**STATE OF MINNESOTA
BEFORE THE PUBLIC UTILITIES COMMISSION**

In the Matter of Xcel Energy's 2025
Integrated Distribution Plan

MPUC DOCKET NO. E-002/M-25-142

**INITIAL COMMENTS ON XCEL'S INTEGRATED DISTRIBUTION PLAN OF
ENVIRONMENTAL LAW & POLICY CENTER,
COOPERATIVE ENERGY FUTURES, AND VOTE SOLAR**

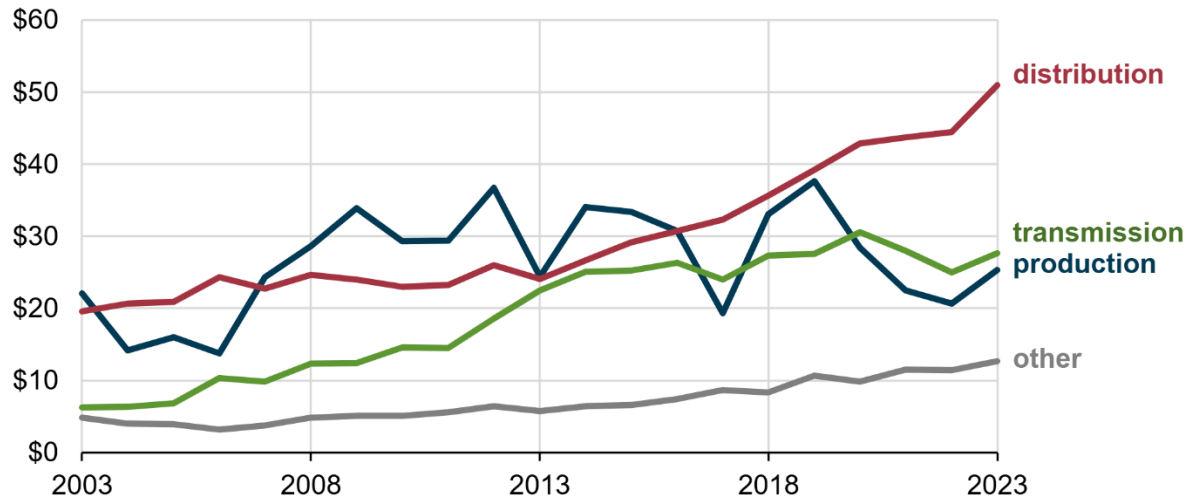
In its Information Request No. 89 (Attachment 3), the Department further demonstrated the significant increase in spending on key categories, comparing average annual spending in 2020-21 to 2026-30, and showing a 291% increase in age-related spending, a 500% increase in capacity spending, and a 215% increase in reliability spending. Responding to the Department's request to explain these increases, Xcel offered relatively limited additional detail. The Company also indicated in the same IR response that it expects the budgets to grow in all three areas in the 2031-36 period.

The significant budget growth—and the Company's expectation that it will continue—demonstrate how distribution spending is squarely at the heart of affordability. Looking across the United States, as shown in the figure below from the U.S. Energy Information Administration (EIA), while generation and transmission costs in recent years are relatively flat, distribution costs are rising steeply.⁴⁸

**Figure 2-9
Project Timeline**

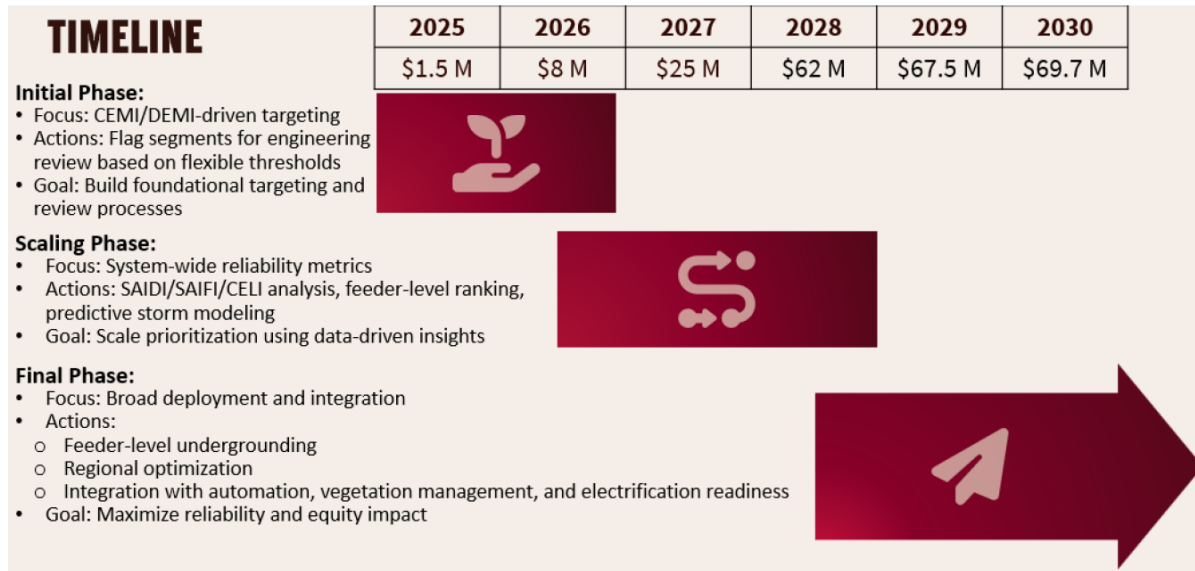
Company later similarly states: “To ensure equitable investment, the Company will incorporate findings from an independent third-party evaluation. This evaluation will inform demographic analysis to identify underserved or vulnerable communities, and community engagement strategies coordinated with local stakeholders and municipalities.”⁶⁵ However, Xcel provides no detail on what relevant findings it expects to get from the study, which ELPC/CEF/VS understand will examine the Company’s capital investment and other internal processes. Moreover, Xcel does not explain how or when it will integrate these findings or equity and demographic considerations in general into its targeted undergrounding plans and processes. Similarly, in IDP Figure 2-9 copied below, the Company identifies its focus on engineering review to drive targeted undergrounding projects in both its Initial and Scaling Phases.⁶⁶ Only in the Final Phase does the Company identify the goal to “maximize reliability and equity impact.” But the Company offers no explanation for when this Final Phase will occur or how it will maximize its equity impact.

Especially given the large budget proposed, ELPC/CEF/VS recommend that the Commission require Xcel to integrate equity considerations explicitly and transparently into its targeted underground program from the start to ensure that communities facing disparities in reliability appropriately benefit in a timely manner. In addition, as discussed further below in Section III.B.17 with respect to integrating equity considerations into planning more generally, we suggest that the Commission require the Company to explore using the Interruption Cost Estimate (ICE) 2.0 Calculator from Lawrence Berkeley National Laboratory to inform this integration. To the extent the ongoing third-party study provides additional insights, Xcel should incorporate those, as well; however there is no reason to delay consideration of equity when the Company has already identified disparities in reliability and targeted undergrounding as a solution.
